Responses to the Comments by Reviewers

**On Coupled Unsaturated-Saturated Flow Process Induced by Vertical,
Horizontal and Slant Wells in Unconfined Aquifers**

Revised version Submitted to *Hydrology and Earth System Sciences*

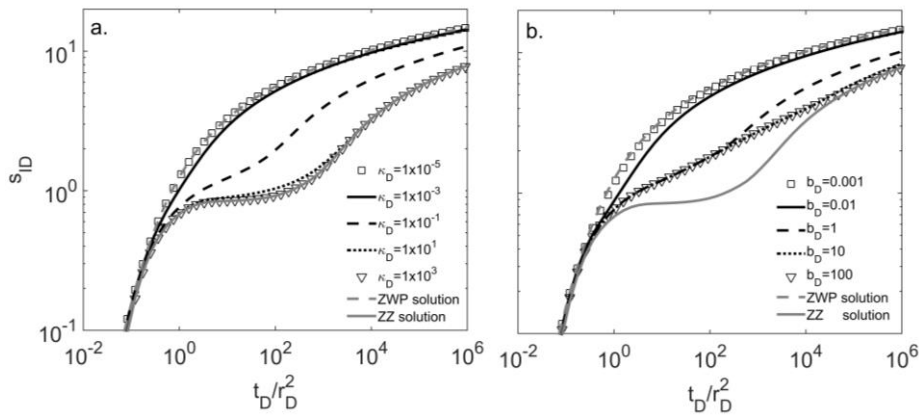
- Line 266: The gray line mentioned here is actually hard to see, due to the aforementioned bad quality of the figures.

3. MN have shown time-drawdown curves for the unsaturated zone; why have LZZL not done likewise? New developments in unsaturated zone sensor technology will likely make it practical, in the not too distant future, to observe unsaturated zone behavior at depth and use the MN (or LZZL) solution to interpret such observations quantitatively.

Response: Implemented. We added Figs. 2c, 2d and 8b to illustrate time-drawdown behavior in the unsaturated zone. These graphs show that both the larger κ_D and the larger

unsaturated thickness b_D lead to the smaller drawdown in the unsaturated zone. We added these statements on lines 334-342.

Figure 8 a) Comparison of synthetic drawdown in saturated zone generating from numerical solution with fitted analytical solutions using ZZ solution, ZWP solution and our solution, and b) Comparison of synthetic drawdown in unsaturated zone generating from numerical solution with our solution.

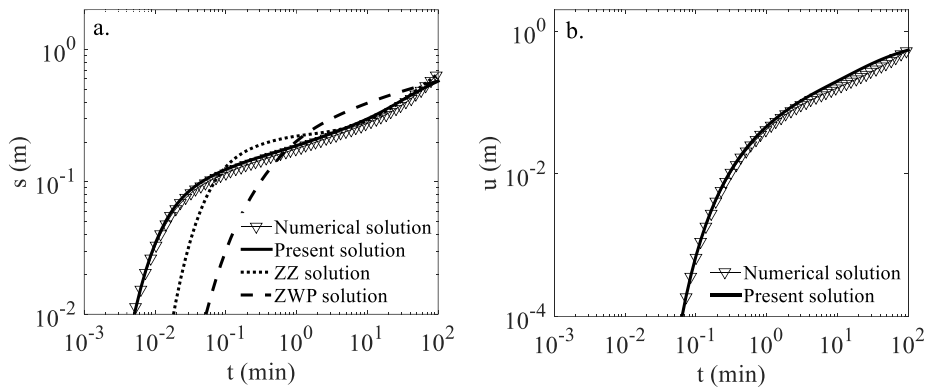
2. In my opinion, the authors fail to properly put their results into context. Instead the authors should better demonstrate why and when the difference between their model and two older models for pumping in coupled saturated-unsaturated systems matter. I am not doubting that their approach has not been done before, but this does not automatically make it relevant and interesting. To show that, the authors should begin by explaining some problems of the two older models, and subsequently demonstrate how their newer approach can remedy these problems. In particular, they should be able to discuss how these observed differences relate to actual real-world features.

4. MN have used their solution to analyze published pumping test results, demonstrating (as already noted) that their new model provides more realistic parameter estimates than did earlier models, including that of TN (and hence, I conclude, LZZL). Why have LZZL not done the same?

Response: Implemented. We adopted this comment and added subsection 4.3 and Figure 8 to demonstrate the problems of two older models (ZWP and ZZ models) on explaining the drawdown curves in the saturated-unsaturated system. A major disadvantage of the two older models (ZWP and ZZ models) is that they did not consider the unsaturated flow process, thus they cannot be used to characterize the parameters of the unsaturated zone. The newer model developed in this study, however, is capable of characterizing parameters of both the saturated and unsaturated zones. As far as we know, this represents a significant improvement over the older models. Furthermore, as the older models did not consider the unsaturated flow process that was proven to be important for producing the drawdown-time curves in the saturated zone, they often cannot satisfactorily reproduce the observed drawdown-time curves in the saturated zone in actual real-world aquifer pumping tests. The newer model has resolved this issue successfully. Please see lines 441-450 of the revised text for addressing this point.

To further demonstrate the difference of the older and newer models, we have conducted a numerical simulation using the finite-element model COMSOL for a synthetic case that considers the unsaturated flow process for a slant well pumping test in an unconfined aquifer.

The results show that our solution nicely reproduces the drawdown curves in both the saturated and unsaturated zones; while the ZWP and ZZ solutions fail to fit the drawdown curves and they either underestimate or overestimate horizontal hydraulic conductivity, specific storage and specific yields due to its lack of consideration of the effect of unsaturated zone. Please see the details in the subsection 4.3 and Figure 8.

In order to demonstrate the parameter estimation advantage using our solution versus previous solutions (ZWP and ZZ solutions), we adopted Reviewer#1 and your suggestions and conducted a numerical simulation using the finite-element model COMSOL to generate synthetic drawdowns in saturated and unsaturated zones. After that, we used ZWP, ZZ and our solutions to fit these synthetic drawdowns and to assess the performance of these solutions. Please refer to our responses to the major comments 2 of Reviewer#1.
